**COA 18-80**

1206 Avenue D

Consideration of an approval for roof replacement.

**HISTORIC PRESERVATION BOARD : PUBLIC HEARING**

Proposed roof

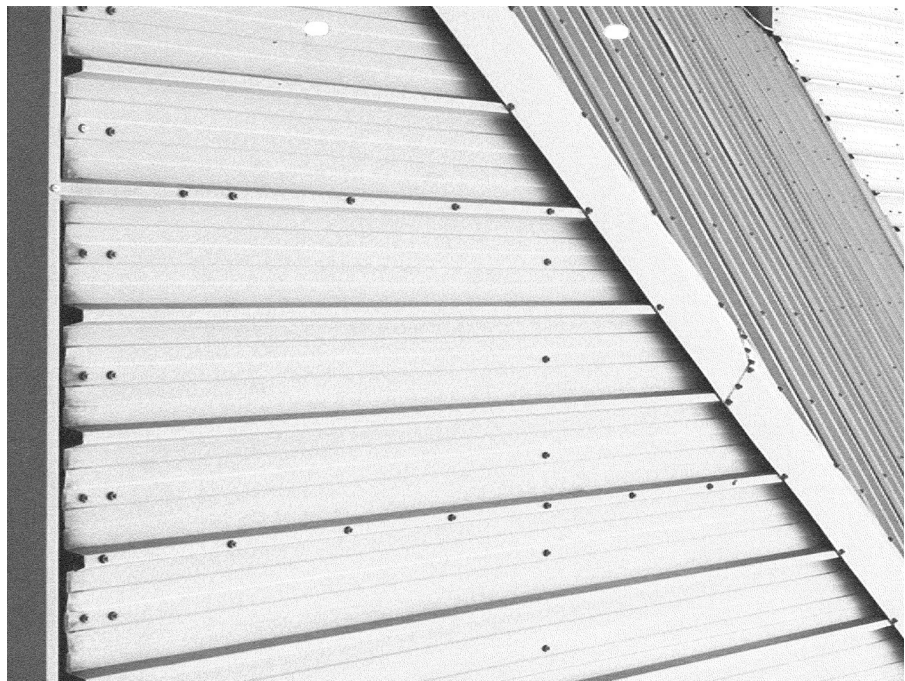
The proposed replacement of the existing flat roof with 5-V crimp metal roof will provide an additional architectural element which will enrich the building form. New roof will be compatible in style and appearance with the current architectural aesthetics of the Lincoln Park Historical District. Granting this request does not present conflict with the Secretary of the Interior Standards. Therefore, staff recommends that the Historical Review Board approve this application for Certificate of Appropriateness as presented.
